# Work Order ID 87563

Item ID: D212-664-101TRN Accept **\*N900040100\*** Setup Start **\*NS1\***  
 Revision ID: Stop **\*NS2\***  
 Item Name: Crosstube Turning Detail  
 Start Date: 7/20/12 Start Qty: 1.00 **\*1\*** Cust Item ID:  
 Required Date: 8/17/12 Req'd Qty: 1.00 **\*1\*** Customer:  
 Reference:

DRAWING NO. D212-664-141	TITLE XTUBE ASSY (205/212/412 HI FWD)	REV. D	DART AEROSPACE LTD ENGINEERING ORDER		D.E.O. NO. D212-664-141-D-1	SHEET NO. SHEET 1 OF 2	SCALE NTS
DRAWN	CHECKED	MFG. APPR.	APPROVED	DE APPR.			
DATE 11.04.07	DATE 11.04.11	DATE 11.04.12	DATE 11/04/12	DATE 11.04.12

ADD AN INSPECTION WINDOW TO UNDERSIDE OF CROSSTUBE.

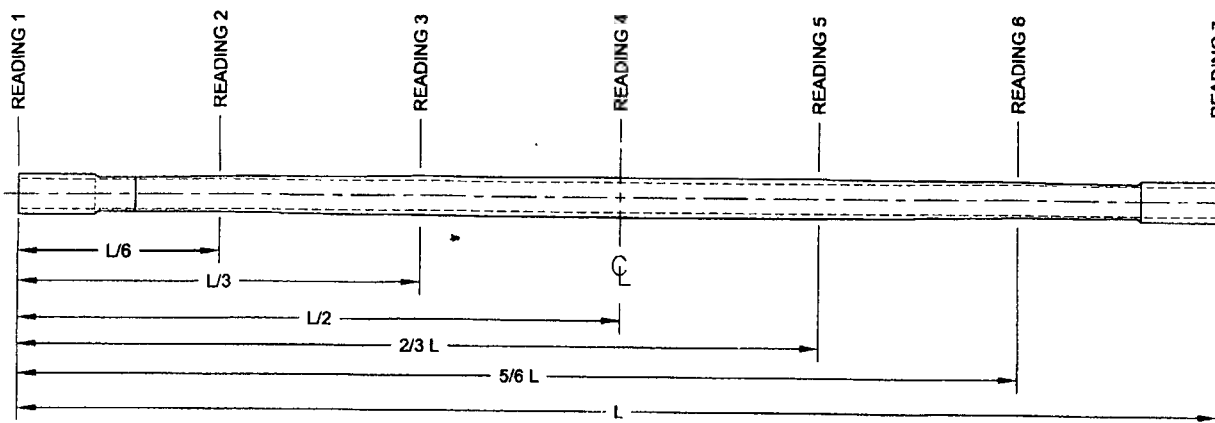
Cuff out of tol

2.744" - 2.738"

(taper)  
OVALITY

Root Cause	Date	Step	Qty	Description of work order update or Non-conformance	Initial Chief Eng	Action Description	Sign & Date	Verification	QC Inspector
Doc/Data <input checked="" type="checkbox"/> Equip/Tooling <input checked="" type="checkbox"/> Operator <input type="checkbox"/> Material <input checked="" type="checkbox"/> Setup <input type="checkbox"/> Other <input type="checkbox"/> Process <input type="checkbox"/> Supplier <input type="checkbox"/> Training <input type="checkbox"/> Unapproved <input type="checkbox"/>	12/8/13	100	1	Cuff is 0.002" below tolerance on O.D.	 12/8/13	Acceptable	 12/8/13	 12/08/13	 057642 12/08/13

**D212-664-141/-141B  
ASSEMBLY DETAIL**

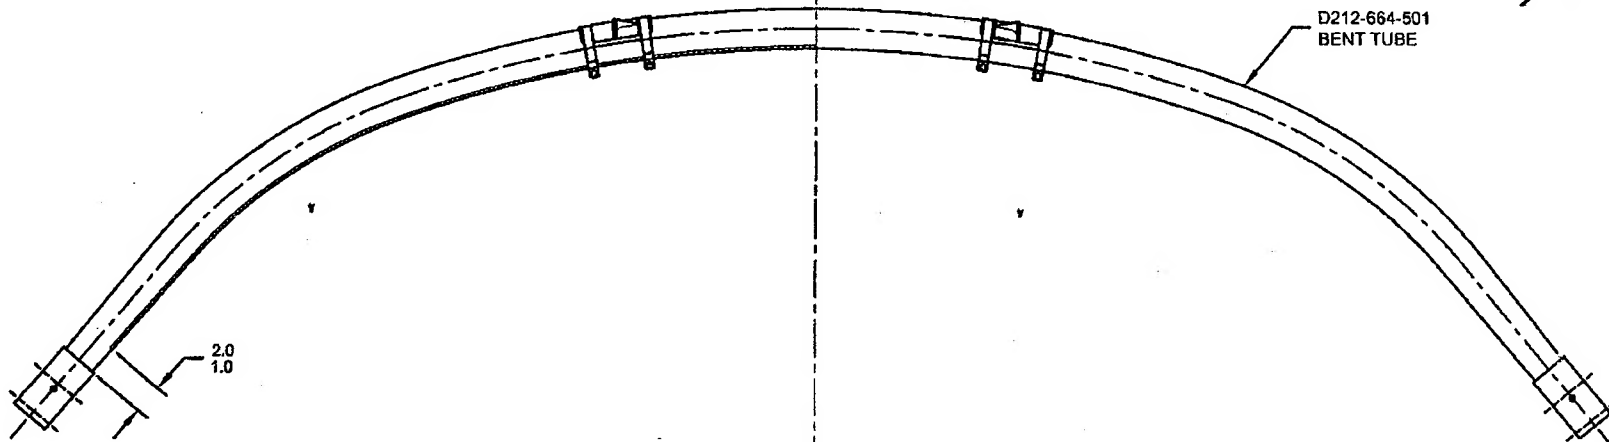
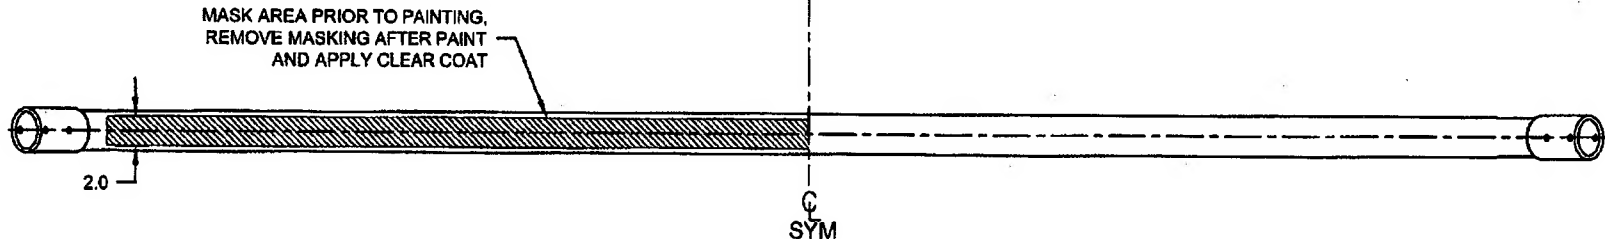
NOTES 2 OF SHEET 1 IS AMENDED AS FOLLOWS:

- 2) FINISH: CHEMICAL CONVERSION COAT PER DART QSI 005 4.1  
PRIME INSIDE AND OUTSIDE PER DART QSI 005 4.2  
MASK UNDERSIDE OF CROSSTUBE AS SHOW (ATCHED AREA) AND  
PAINT OUTSIDE PER DART QSI 005 4.2  
REMOVE MASKING AND APPLY CLEAR COAT

- 2) FINISH: CHEMICAL CONVERSION COAT PER DART QSI 005 4.1  
PRIME INSIDE AND OUTSIDE PER DART QSI 005 4.2  
PAINT OUTSIDE PER DART QSI 005 4.2
